RLH OA 24-10

APPLICATION FOR APPEAL

REQUEST FOR FENCE VARIANCE
 \$85.00

ADDRESS OF VARIANCE: 63 Arlington Ave, Saint Paul, MN 55104		
OWNER ADDRESS: 414 Nicollet Mall, Minneapolis, MN 55401		
CONTRACTOR ADDRESS: 414 Nicollet Mall		
CITY: Minneapolis	STATE: MN	ZIP: 55401
PHONE: 612-216-8083	FAX:	EMAIL: brian.e.sullivan@xcelenergy.com

PID NO.: 192922240035
ADDRESS: 63 ARLINGTON AVE E.
ST. PAUL, MN 55117

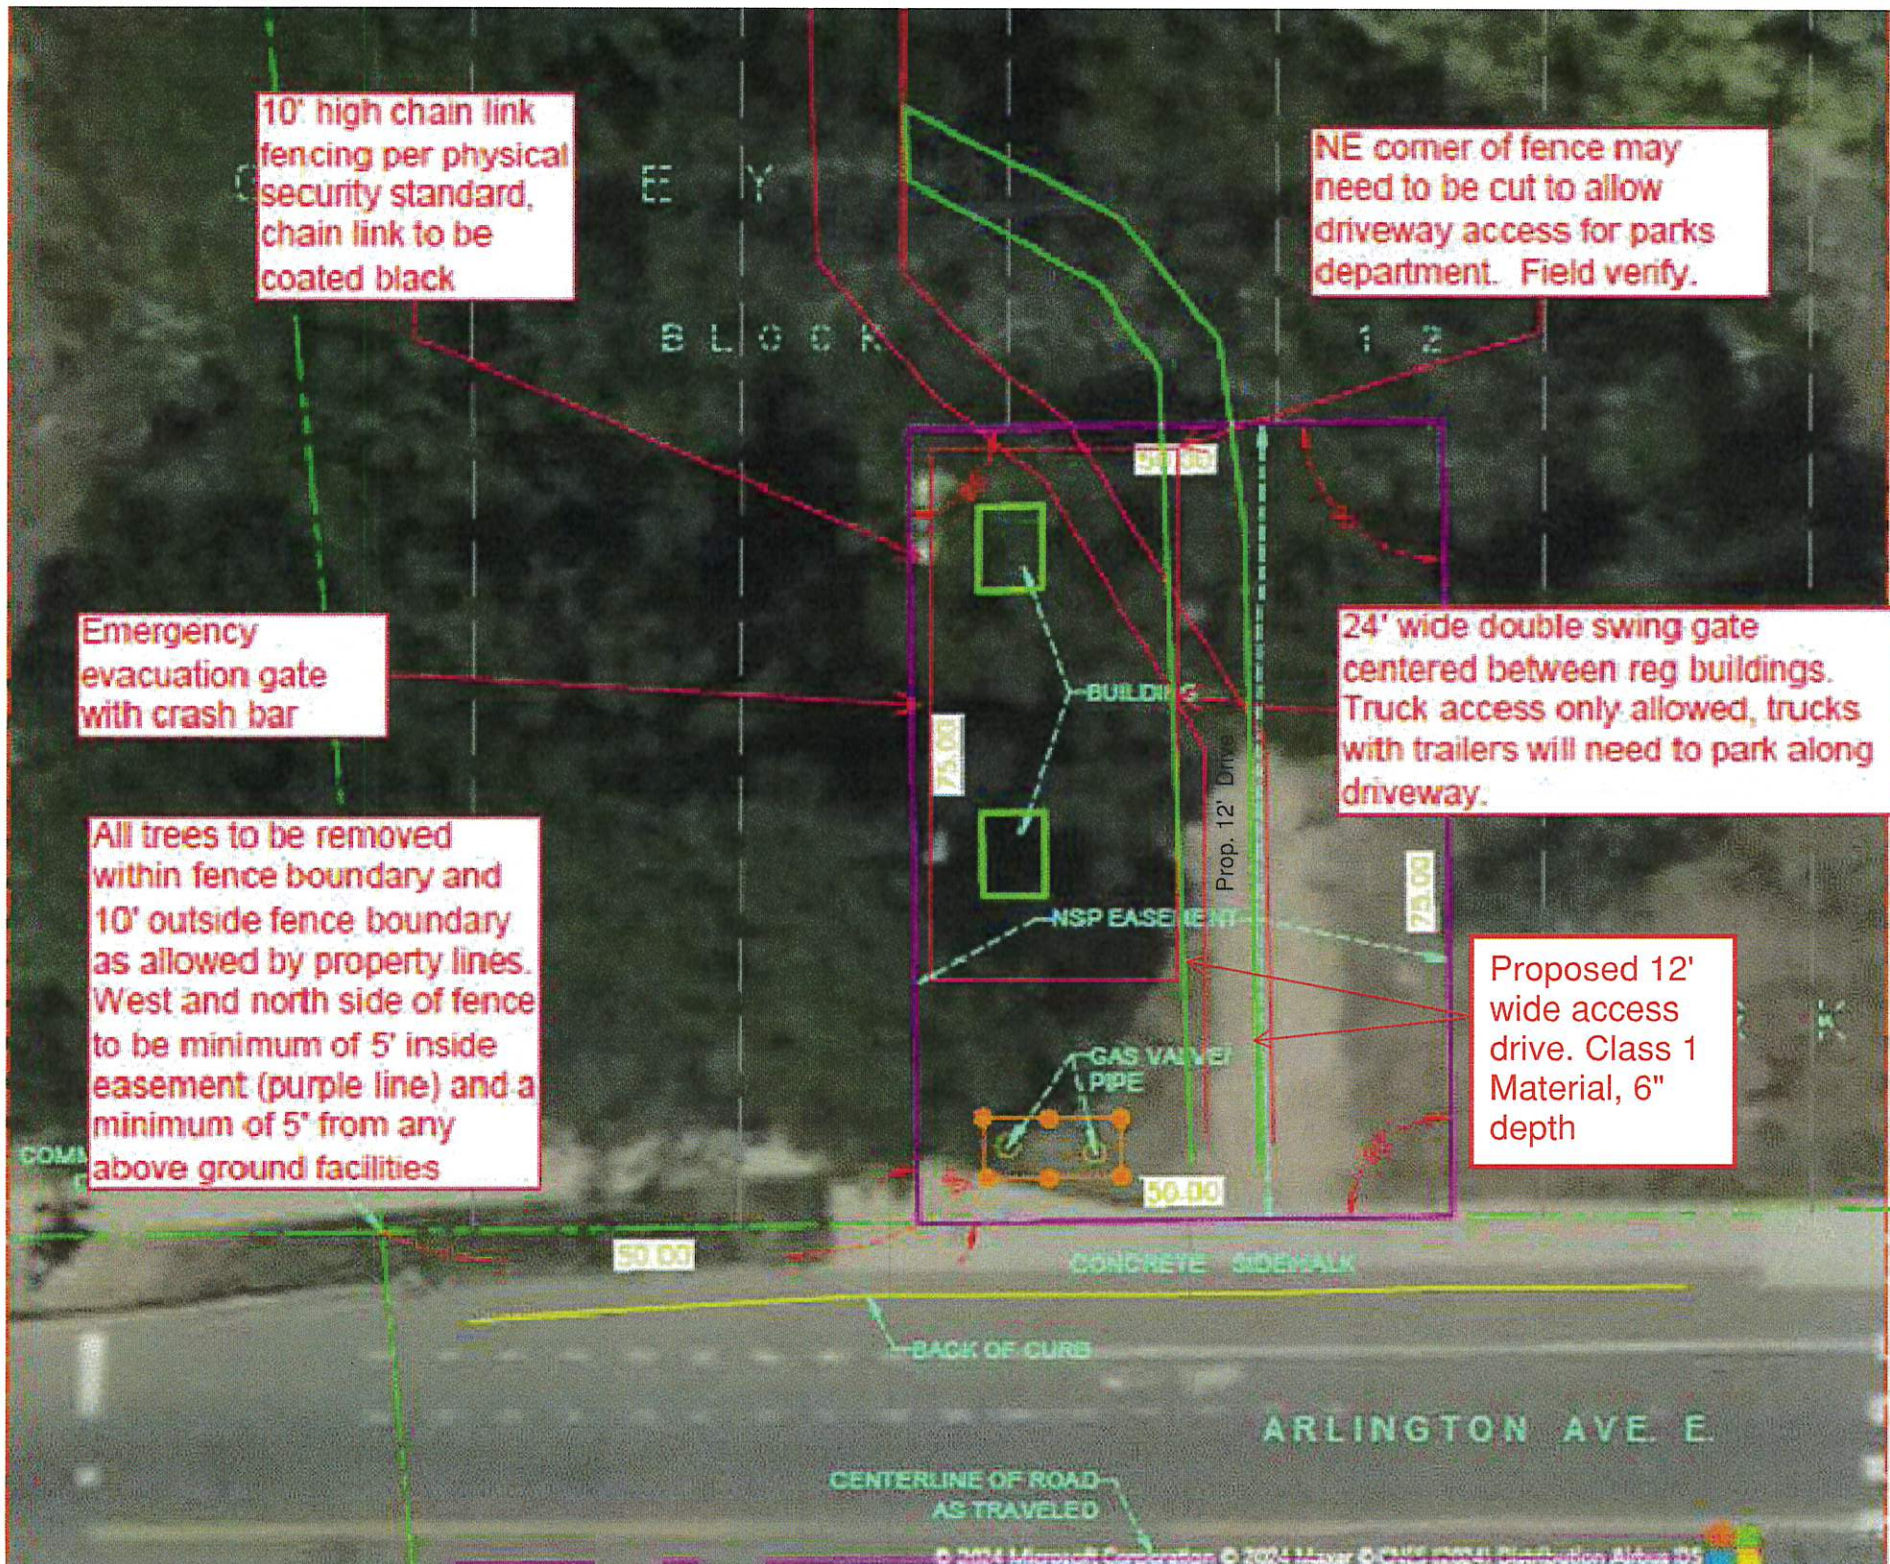
Xcel Energy agrees to revise fence submittal. Sewer Utility has no further objections to the Xcel Energy proposed fence, after submittal is revised to include:

- A 45-degree cut on the northeast corner of the fence to facilitate city access to the Arlington-Jackson stormwater pond.
- Grading of a vehicle and equipment access path that is located to the north of the eastern fence line. The access path should be at least 12-ft in width.
- Removal of tree stumps in the access path.
- Placement of aggregate surfacing for the access path. Material used should be surface aggregate class 1, minimum of 6-in thick, and conforming to MnDOT spec 3138 Aggregate for Surface and Base Courses.

- This property is zoned H1 Residential. [Section 33.07\(c\)](#) states that "Fences for nonresidential uses in residential zoning districts must not exceed eight (8) feet in height" – so a 10 foot high fence would require a Fence Variance

- What style of gate is the 24' wide gate? Sliding, double swing, etc. - How does it open? We'd like to see this on the site plan to verify the gate won't swing especially over the property line, but also will the gate swing over the easement? **The gate is a swing gate and can swing inwards and outwards**

- Can you label the lineal feet of fencing on the site plan? I'm getting that it seems like it'd be more around 250-275 linear feet of fence rather than 375' but that's just me estimating based off a satellite image of the lot. **The fence is 250' in length**

NE corner of fence may need to be cut to allow driveway access for parks department. Field verify.

24' wide double swing gate centered between reg buildings. Truck access only allowed, trucks with trailers will need to park along driveway.

Proposed 12' wide access drive. Class 1 Material, 6" depth

10' high chain link fencing located at easement. Length is 250'

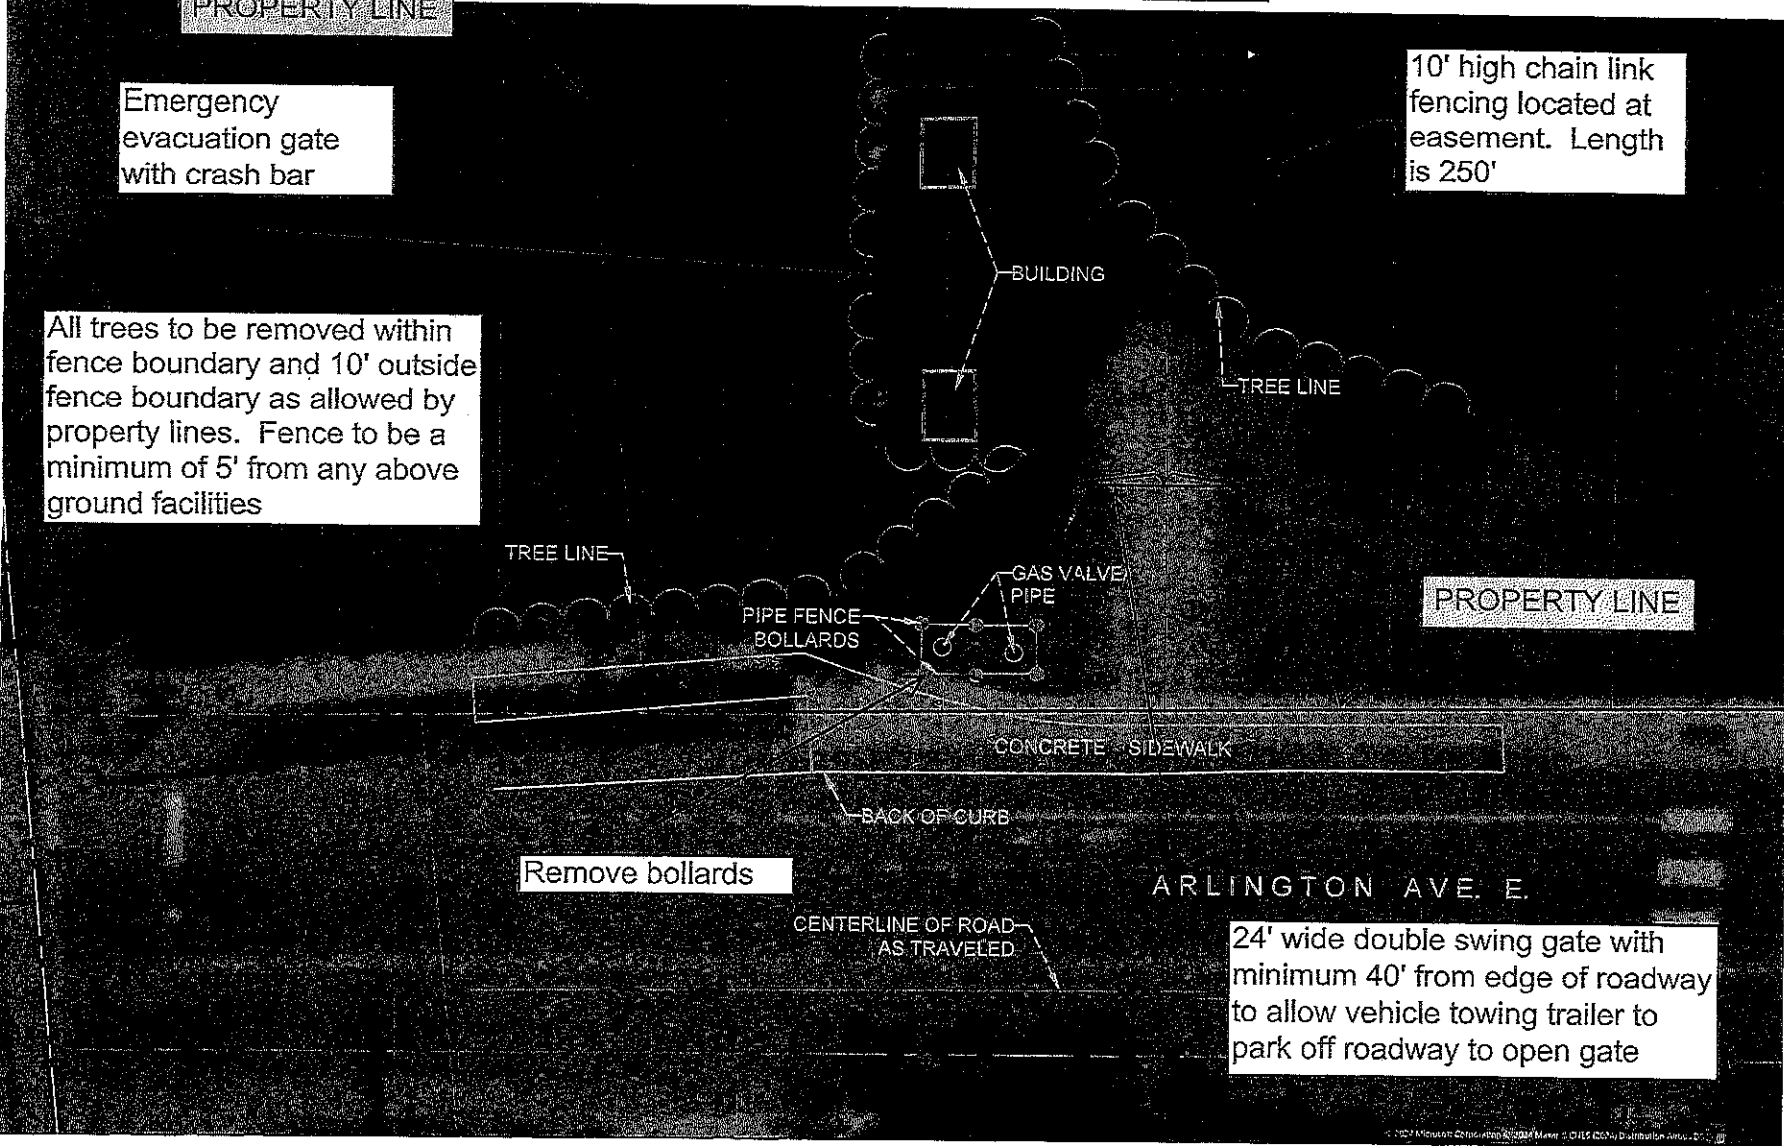
- Because this fence is over 7' in height it is a fence permit (same as a building permit) and not just a plan review. So when it's over 7 feet we then need to know and review more information on how the fence is constructed with regards to footings (depth, size, spacing) posts, gate, etc. – please provide more info on how the fence is to be constructed **Details of the fence are attached.**

All trees to be removed within fence boundary and 10' outside fence boundary as allowed by property lines. Fence to be a minimum of 5' from any above ground facilities
